CITY OF FREDERICKSBURG HISTORIC REVIEW BOARD

TUESDAY, MARCH 15, 2022

7. CERTIFICATE OF APPROPRIATENESS APPLICATIONS

OUTBUILDING—RELOCATE ON PROPERTY

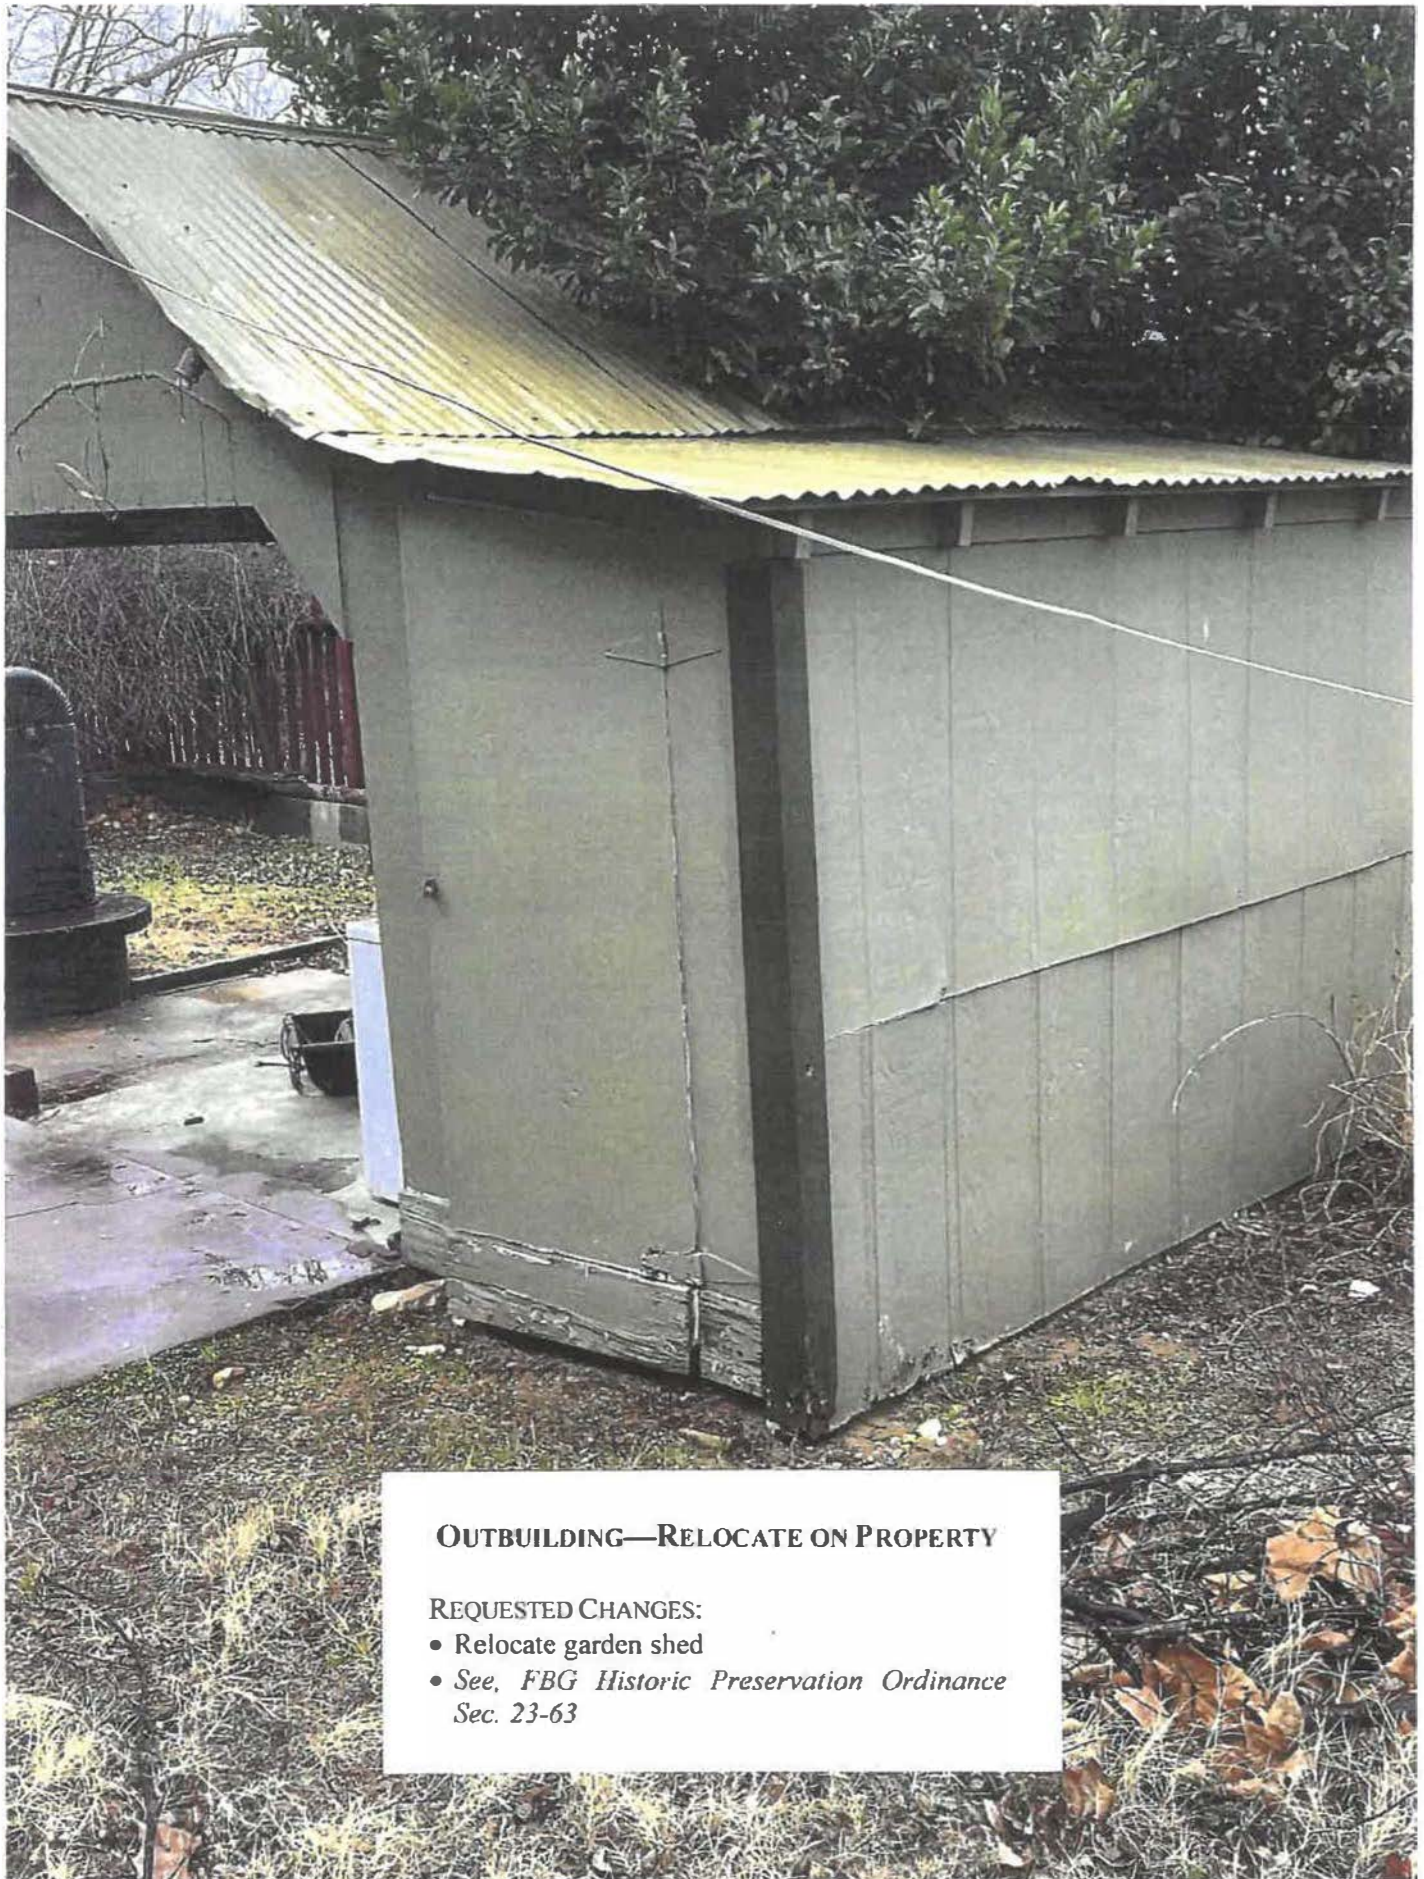
- Relocate garden shed
- See, *FBG Historic Preservation Ordinance Sec. 23-63*

OUTBUILDING—RELOCATE ON PROPERTY

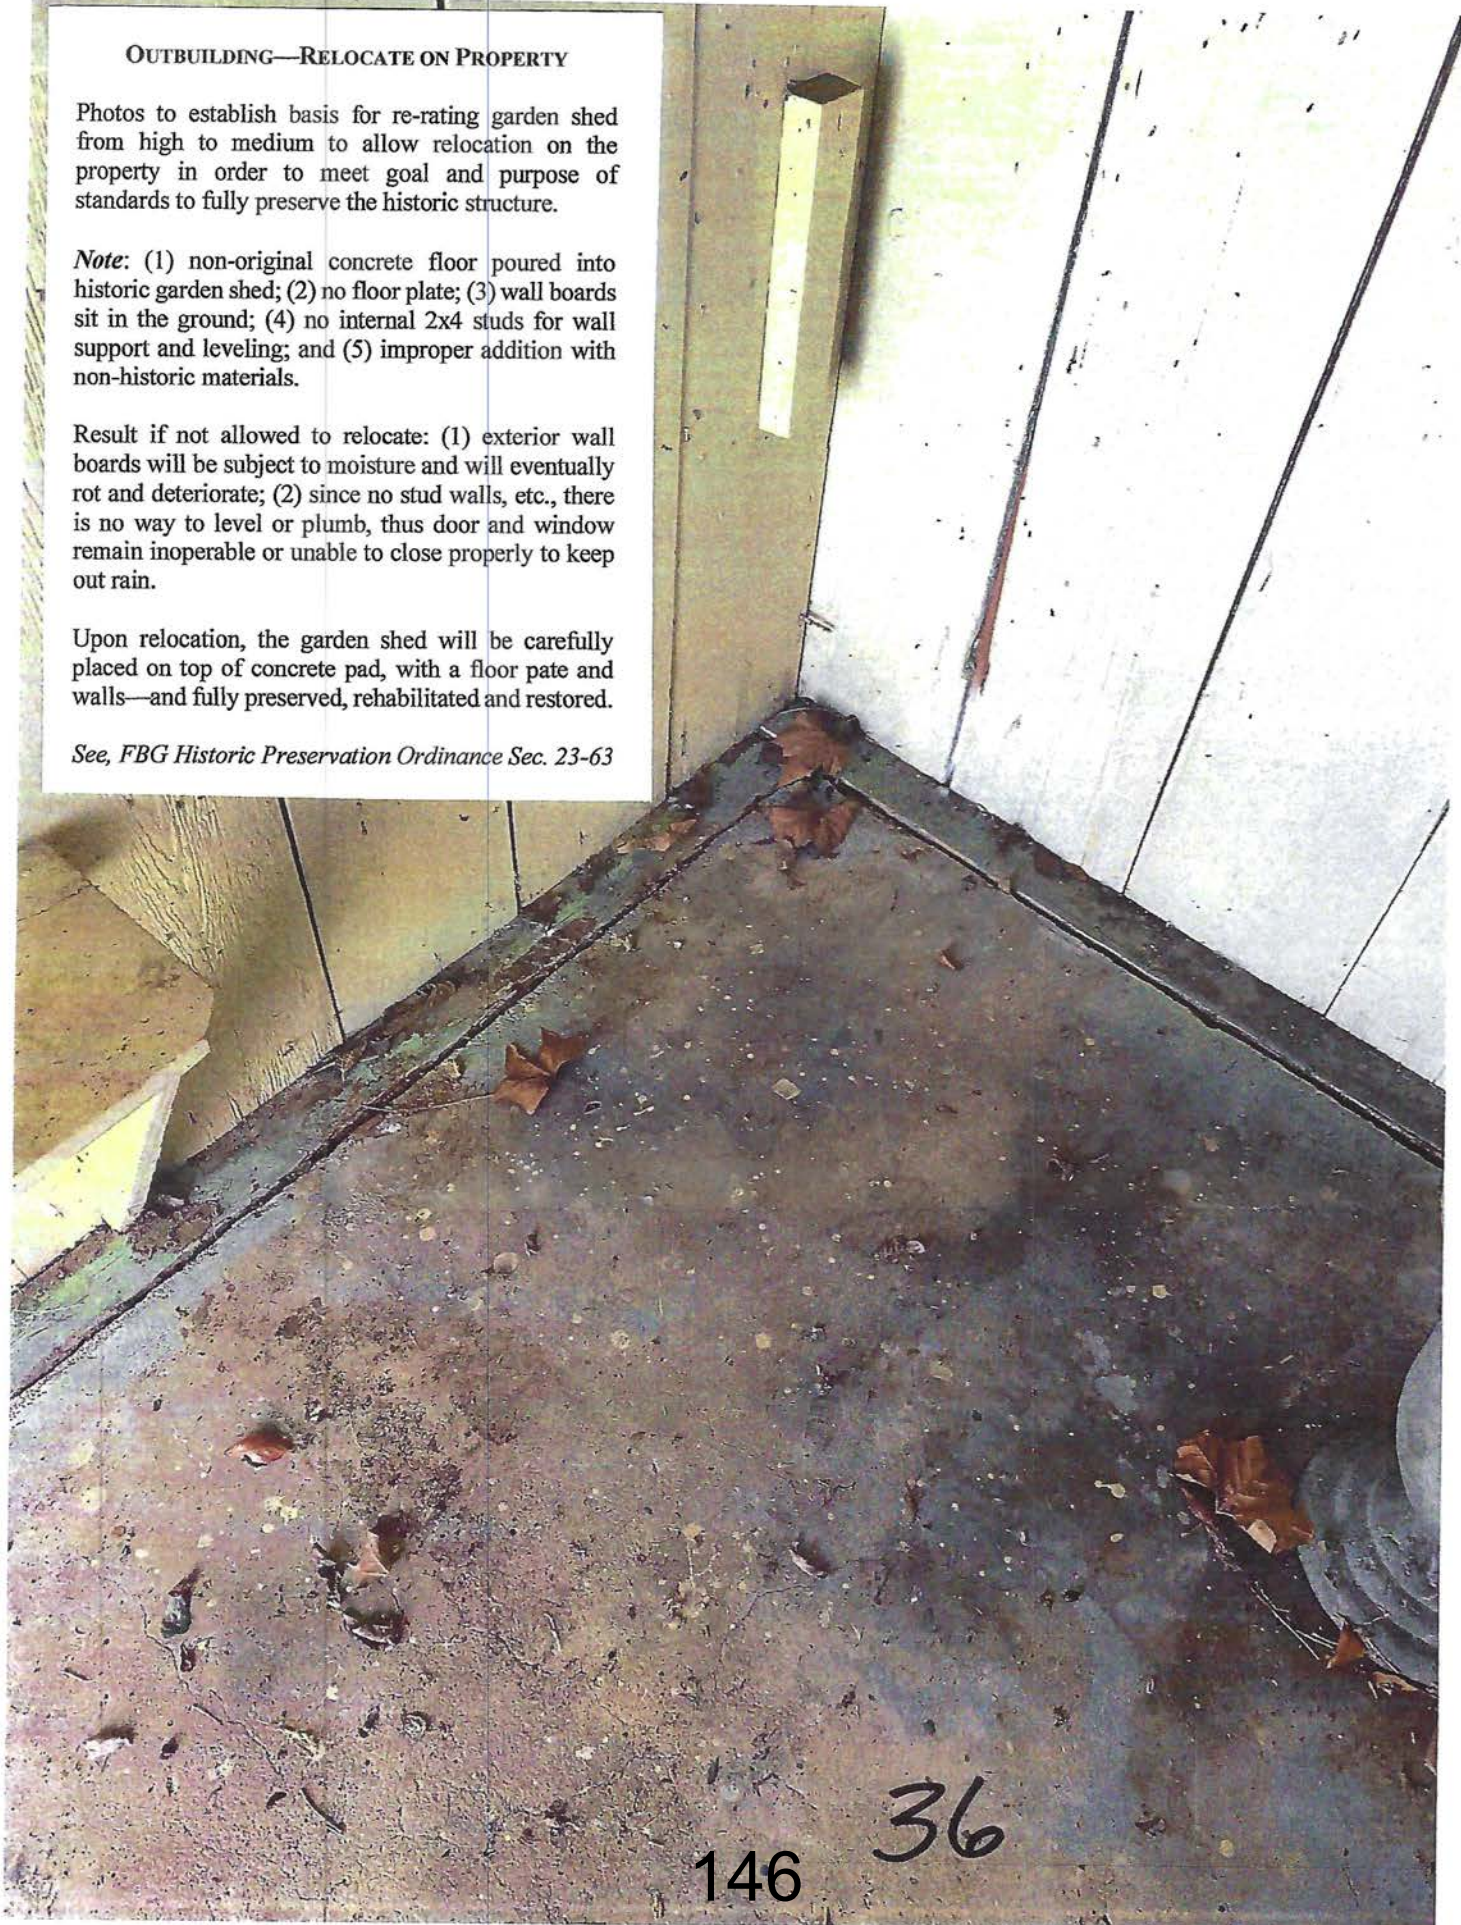
Photos to establish basis for re-rating garden shed from high to medium to allow relocation on the property in order to meet goal and purpose of standards to fully preserve the historic structure.

Note: (1) non-original concrete floor poured into historic garden shed; (2) no floor plate; (3) wall boards sit in the ground; (4) no internal 2x4 studs for wall support and leveling; and (5) improper addition with non-historic materials.
